**Town of Kittery
Planning Board Meeting
December 14, 2023**

ITEM 4—27 & 29 Wentworth—Major Site Plan — Final Review

**Re: Site Plan Review
Tax Map 9, Lots 37 & 38
27 & 29 Wentworth Street
P5431**

EXISTING CONDITIONS PLAN
FOR
MADBURY REAL ESTATE VENTURES
OF
TAX MAP 9, LOTS 37 & 38
27 & 29 WENTWORTH STREET
KITTERY, MAINE

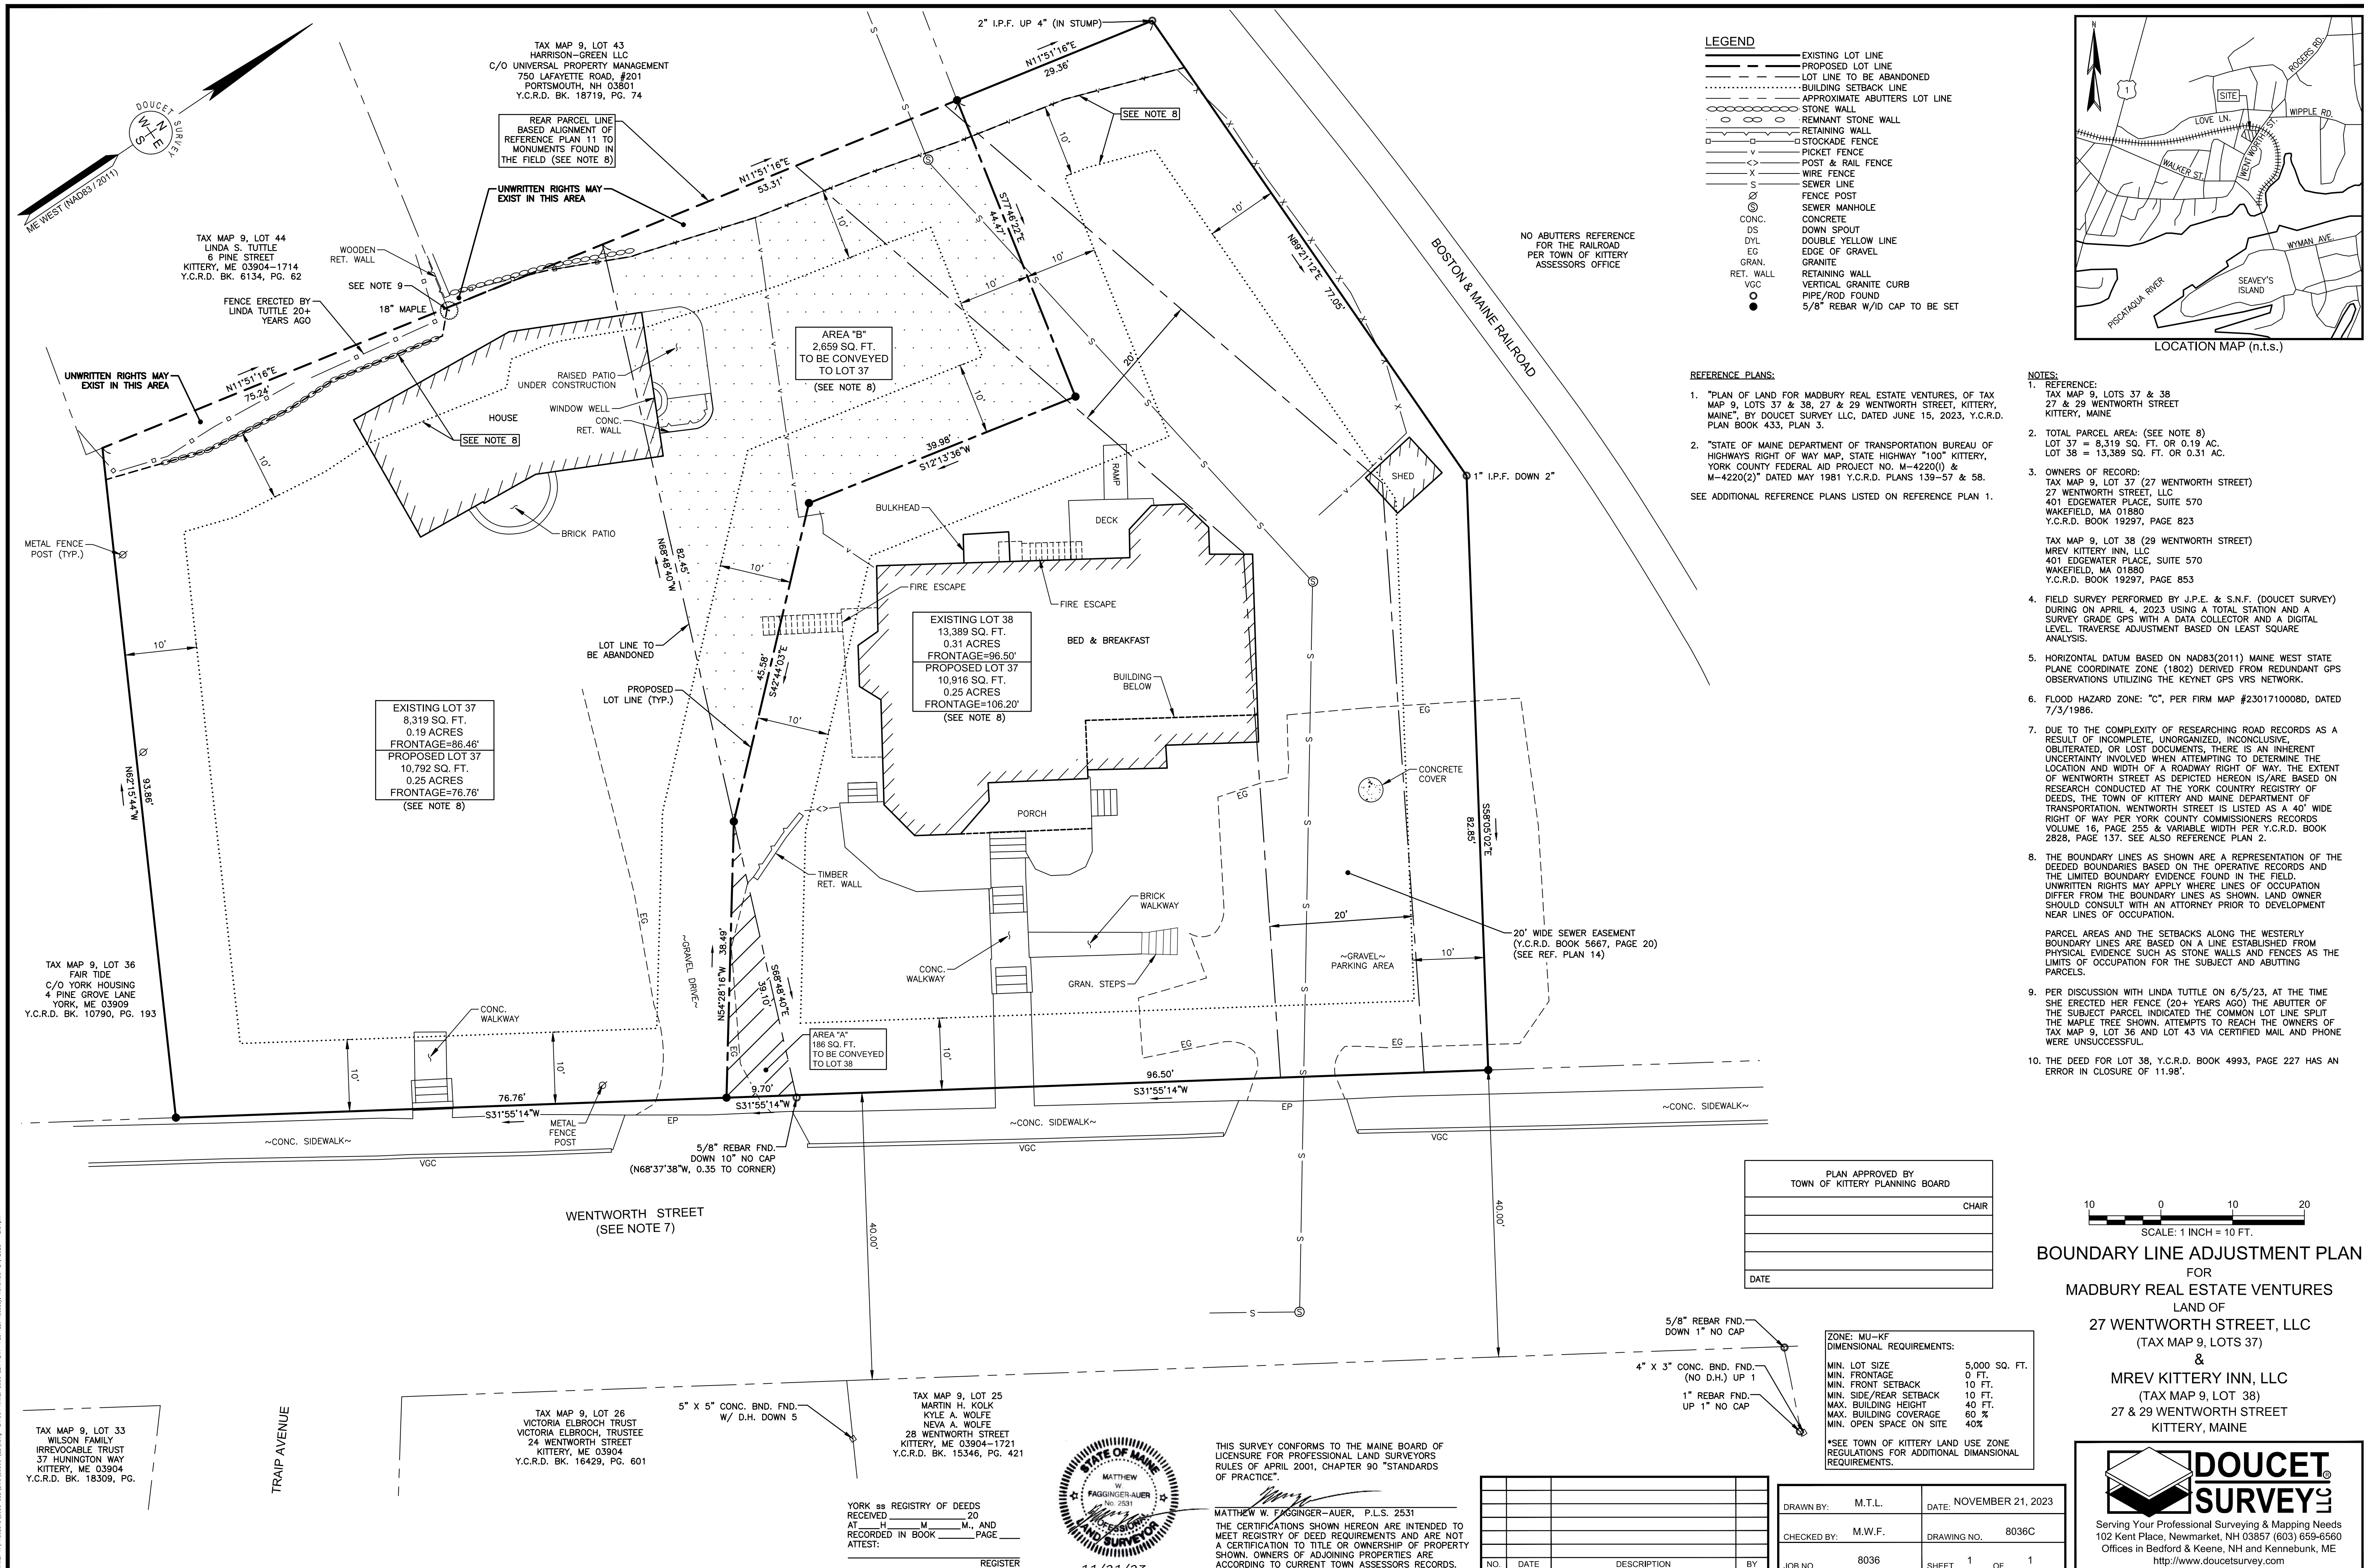
1. Note 1 has one of the addresses incorrectly listed as 28 Wentworth Street. This comment remains unaddressed. **Altus: The surveyor previously made the corrections in a couple of locations but missed Note #1. The revised plan correct Note #1.**

SHEET NUMBER:
C - 1

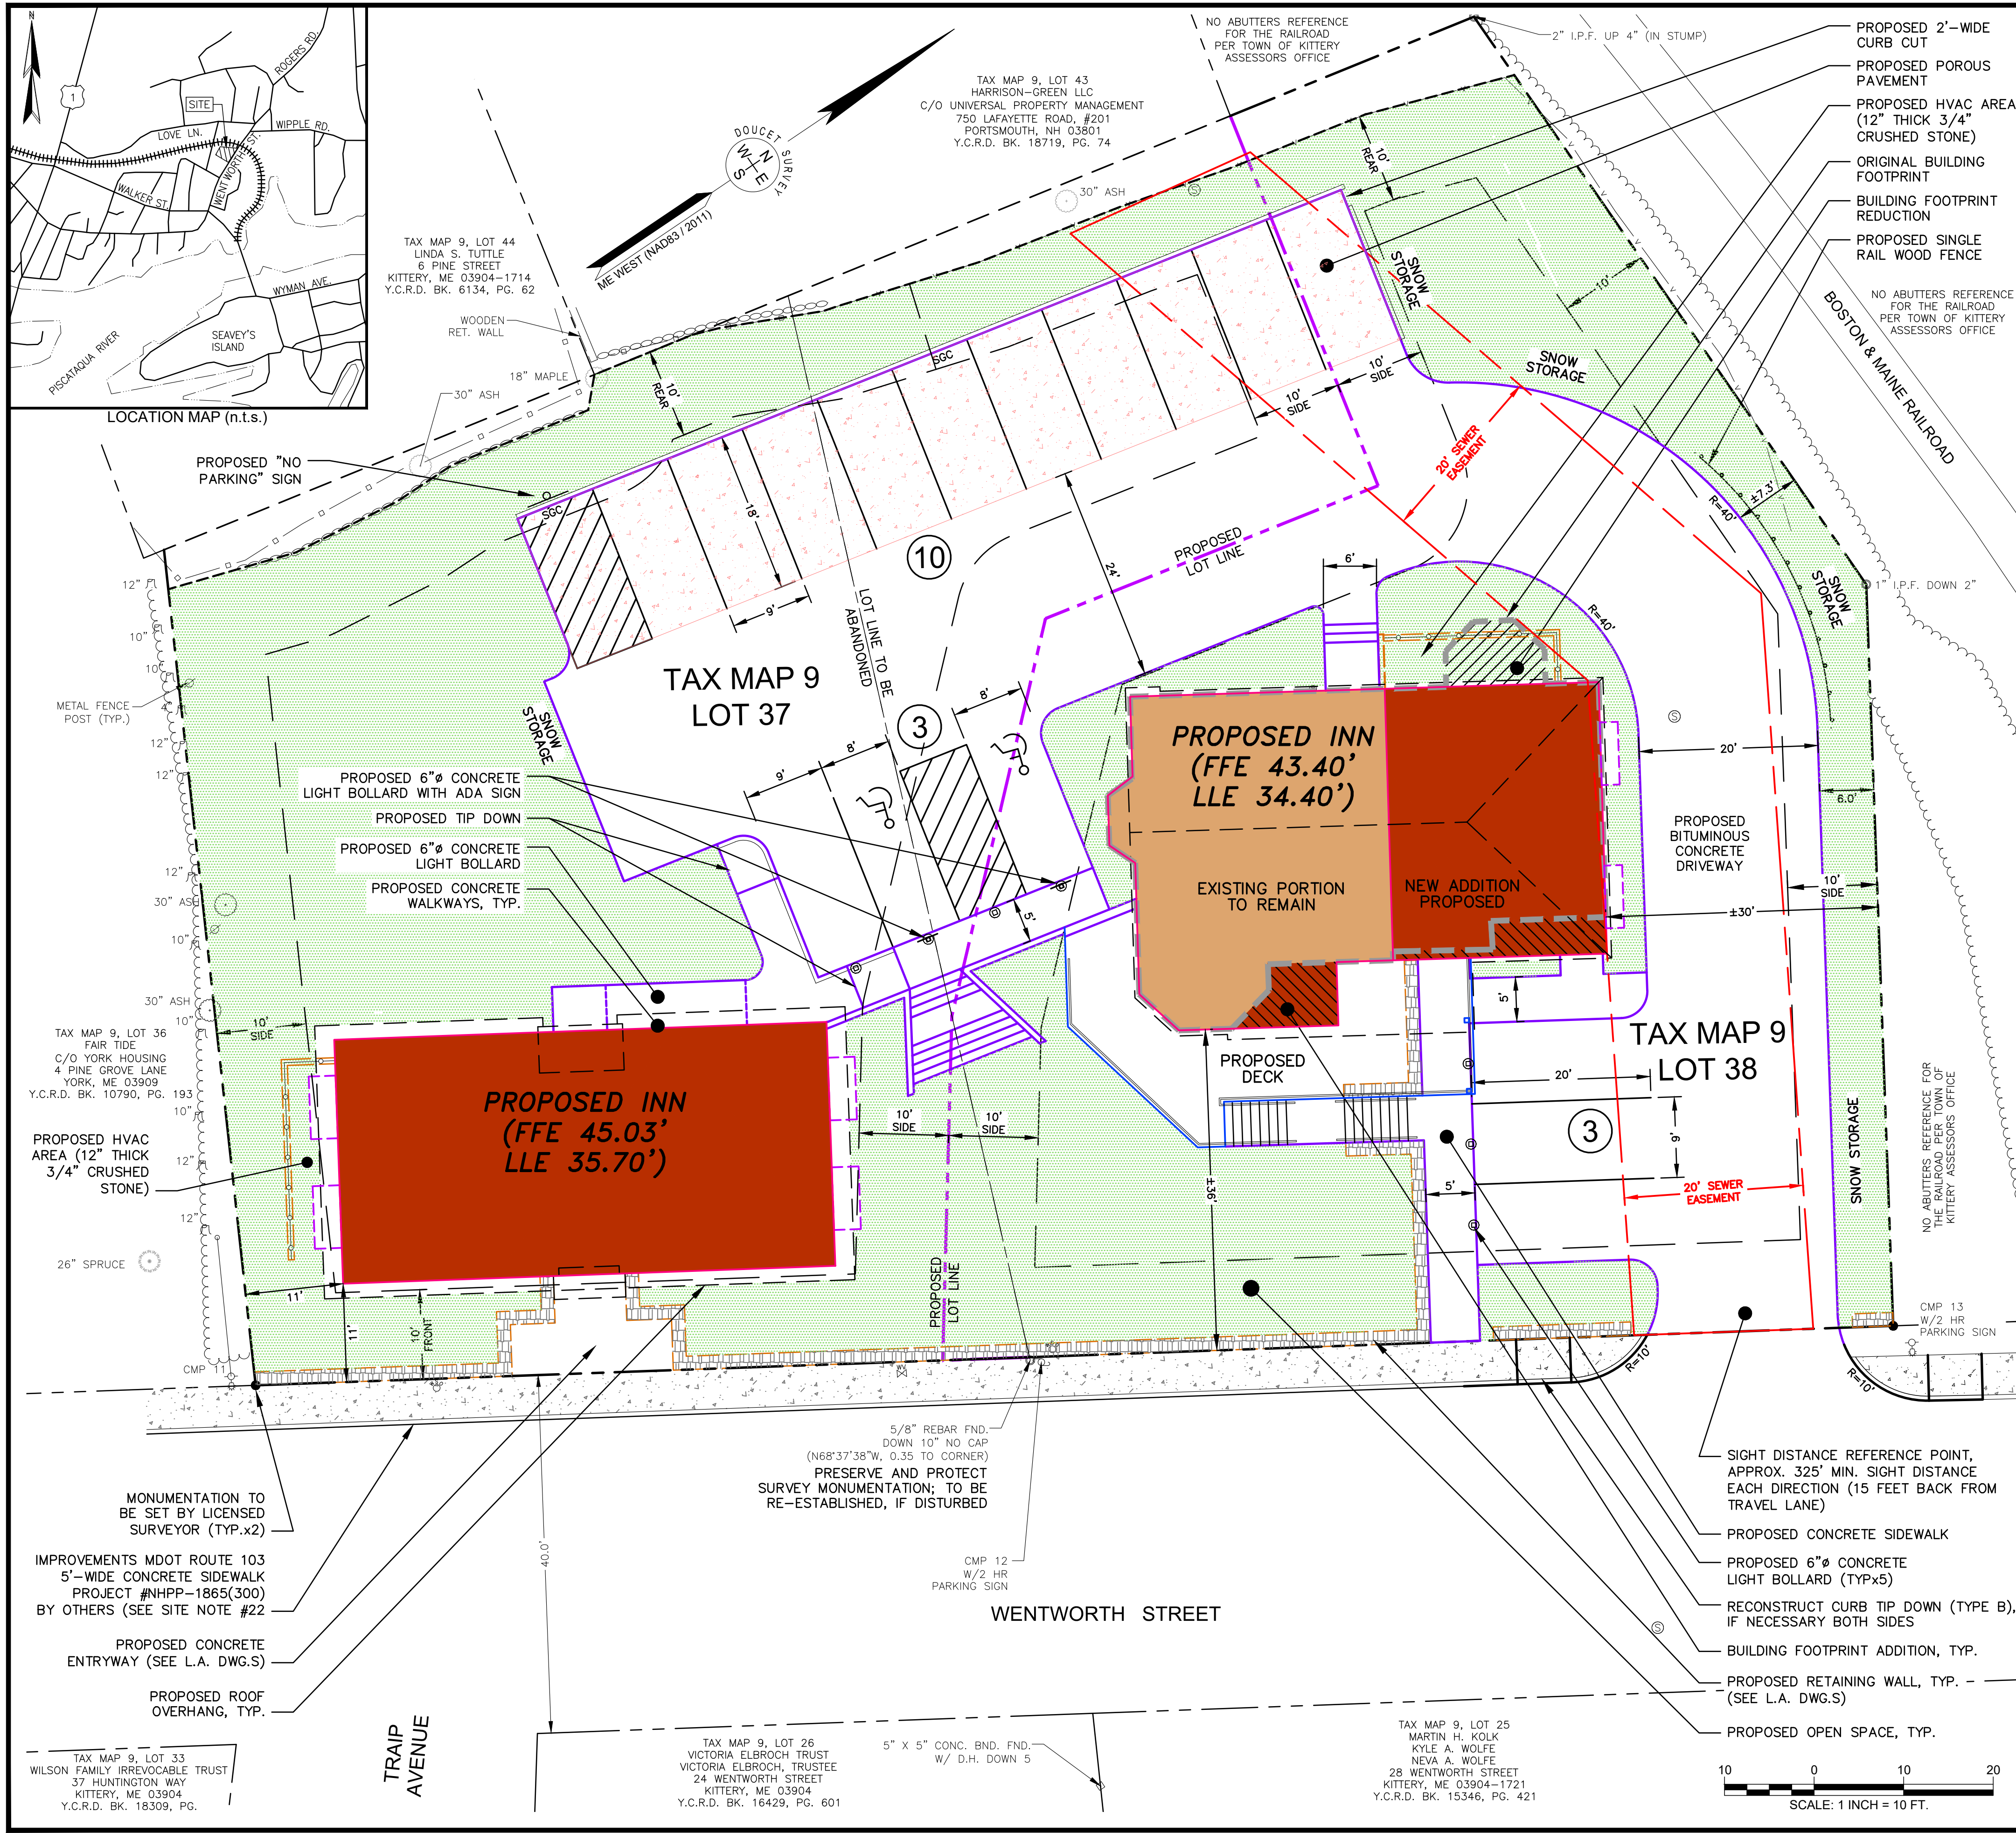
Sheet C-1: Site Preparation Plan

1. Verify that Kittery Water District wants the two old services cut and capped 2’ beyond the property line and not at the property line or at the main. This comment remains unaddressed. Provide documentation from KWD that the proposed design is approved. **Altus: Our previous discussion with the KWD had been verbal. See attached approval letter from KWD.**
2. Where are the existing sewer services located? What abandonment or demolition is planned for them? This comment remains unaddressed. **Altus: The existing services are proposed to be reused. The exact locations were based on tie sheets provided by KSD. Notes have been added to the plans requiring the locations to be verified in the field. See attached approval letter from KSD.**

STORMWATER MANAGEMENT GALLERY - A N.T.S.

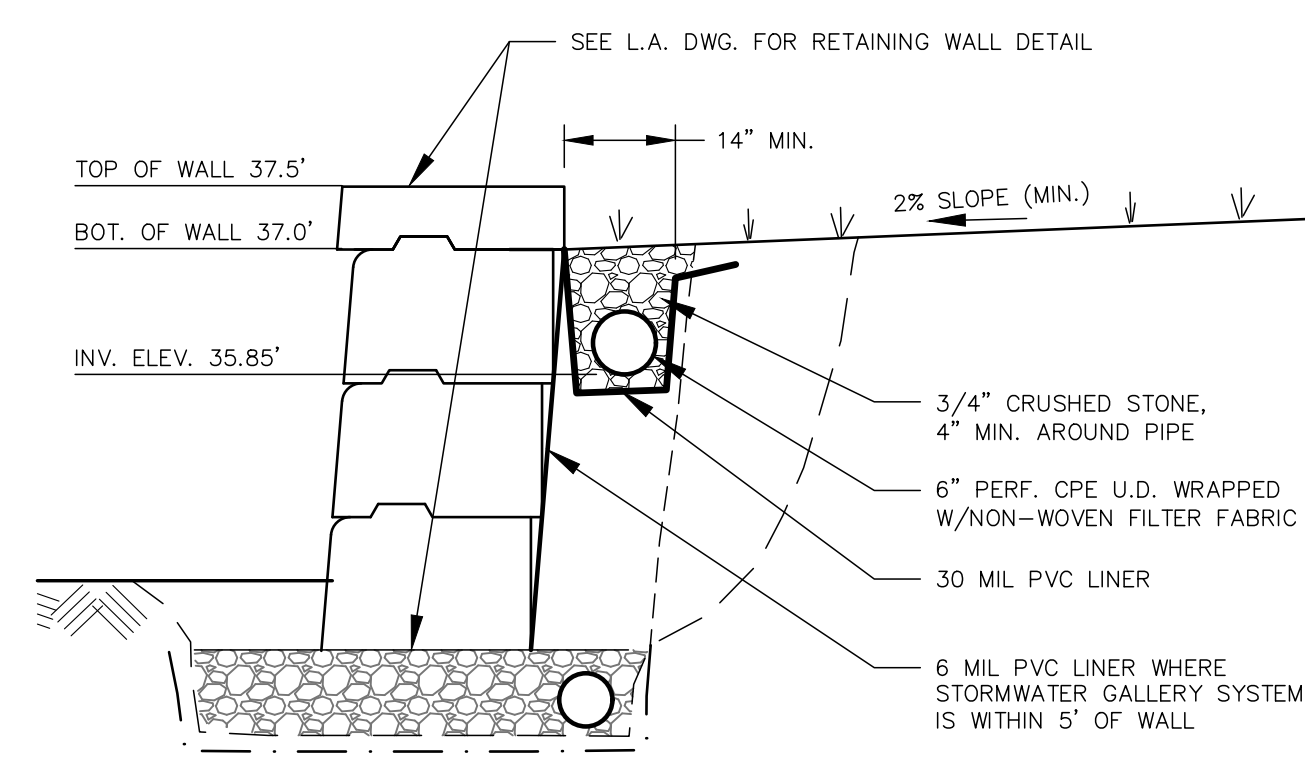
1. What is the ground treatment above the stormwater management gallery? Loam and seed? This information should be shown in detail. This comment was unaddressed. **Altus: Both the Grading Plan and the Landscape Plan indicate that the surface is intended to be loam and seed. The details have been modified to further clarify this issue.**

2. Are there access/cleanout ports for the stormwater gallery other than from the area drain? **Altus: Inspections ports (clean outs) have been added to each galley run to improve maintenance.**

1. The elevations in the model are not the same as those shown on the detail Stormwater Management Gallery – A on Sheet C-8 (Detail Sheet).
2. The stormwater management galleries are modeled differently, Gallery B shows storage above the crushed stone elevation and Gallery A does not. Please clarify.

DRAINAGE AND SEWER TRENCH NOT TO SCALE

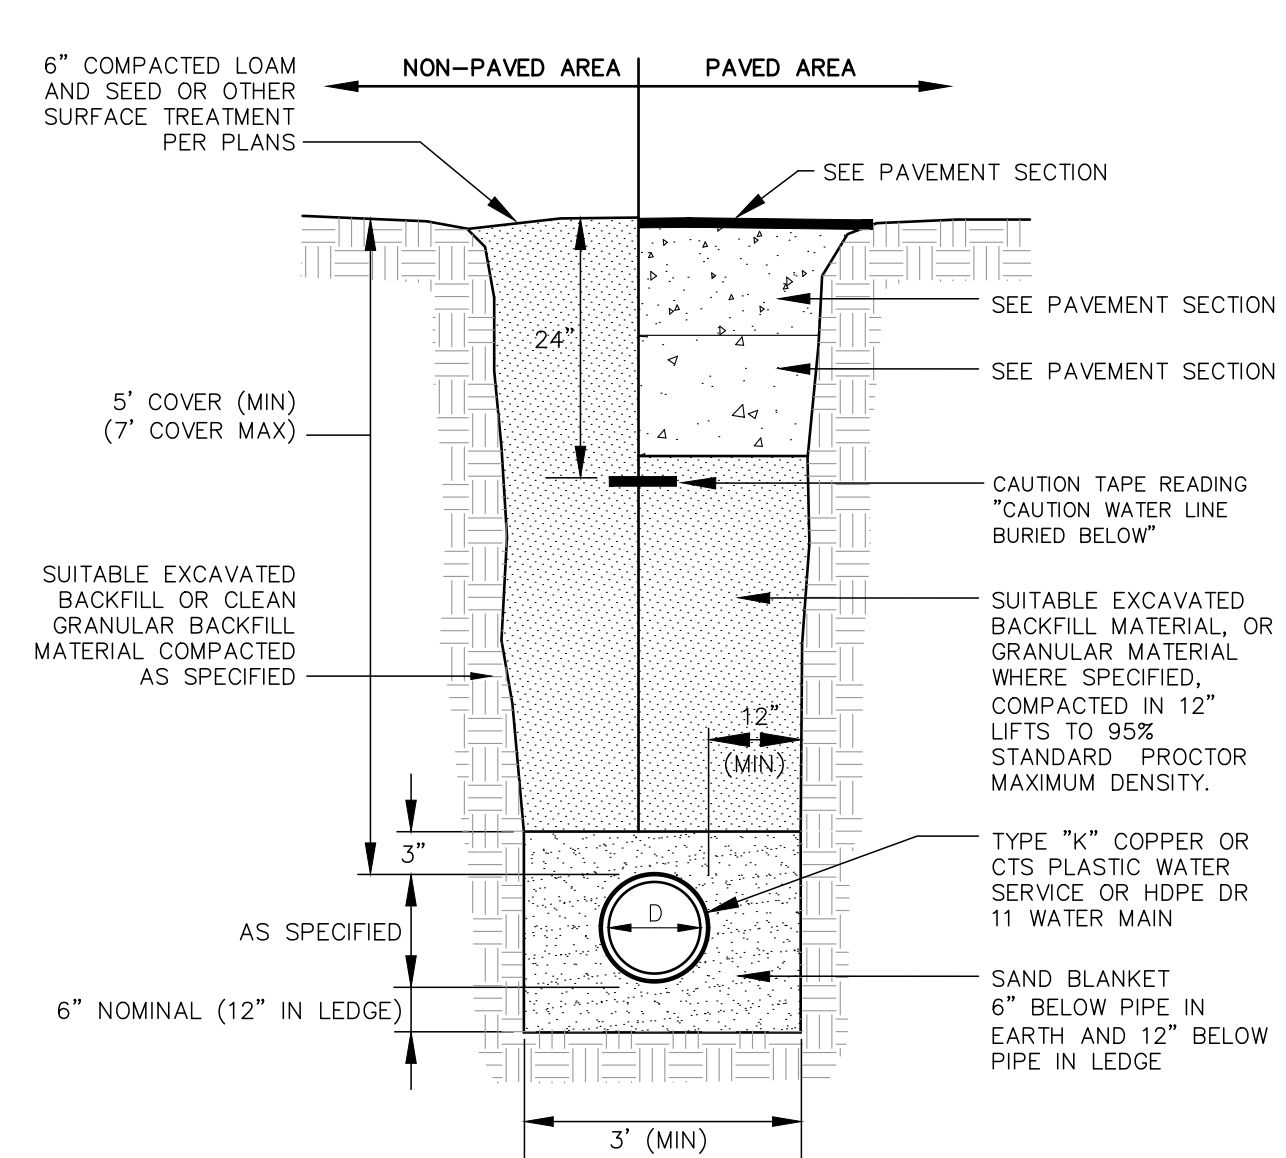
1. Remove the wood sheeting from the Drainage and Sewer Trench detail. **Altus: The wood sheeting has been removed from the drainage and sewer trench detail as requested.**
